Memo

Change Order #1: ADA Upgrades for North Main

17-00000-01-RS

N.Main ADA Ramps

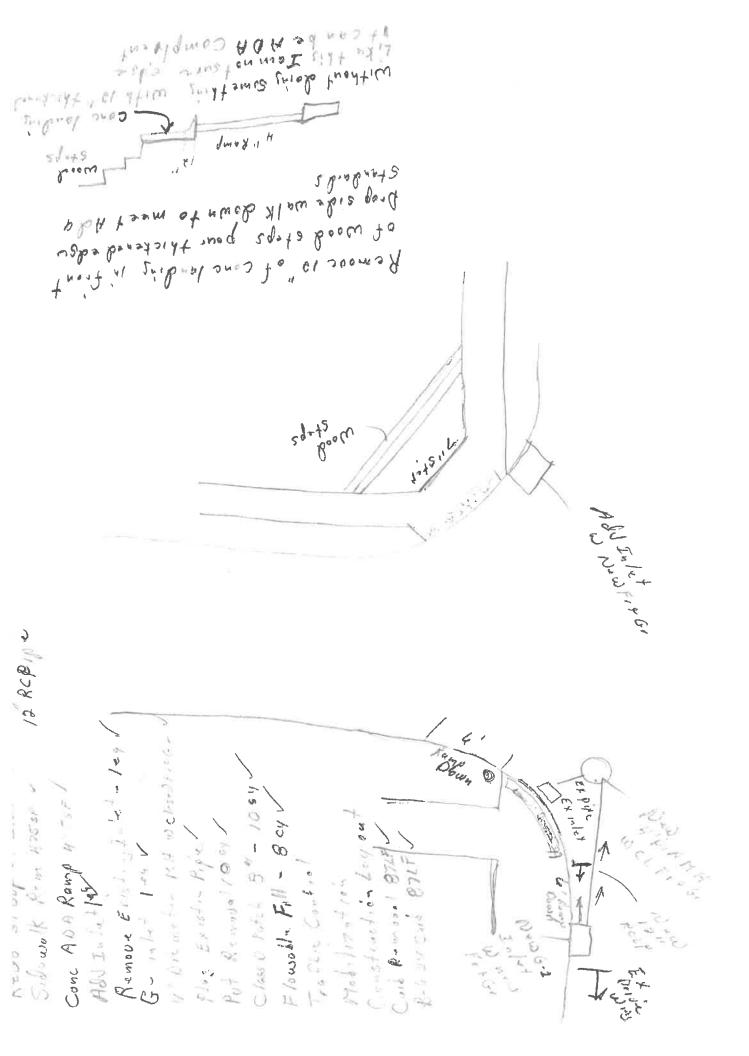
Detailed review of current inlet conflicts as well as adjacent constraints with the porch at the Historical Society necessitate the relocation of the SW inlet, detailed in the attached sketch.

An additional step is propsoed to be added to allow for a lower point of tie-in and create a current code conforming ADA ramp.

Rather than reconstructing private stairs at this location, it is proposed that the radius return in NE quadrant be reconstructed further south to wrap around the power pole in the pavement, providing an additional degree of clear zone protection and allow for construction of ramp without conflicting with the existing stairs.

One G-1 inlet will be relocated and a new casting provided

One G-1 inlet is in disrepair and is quoted to be removed and replaced and a new casting provided

Two inlets are quoted to be adjusted. The castings are old, on these inlets new castings have not been quoted for these inlets. If the city wants new castings an agrreed unit price can be provided

The ADA ramp on Zinser at the museum will be difficult to achieve. I have given a unit price to remove 12" of the front of the stoop, create a step and lower the ramp to the right elevation to meet the ADA standards
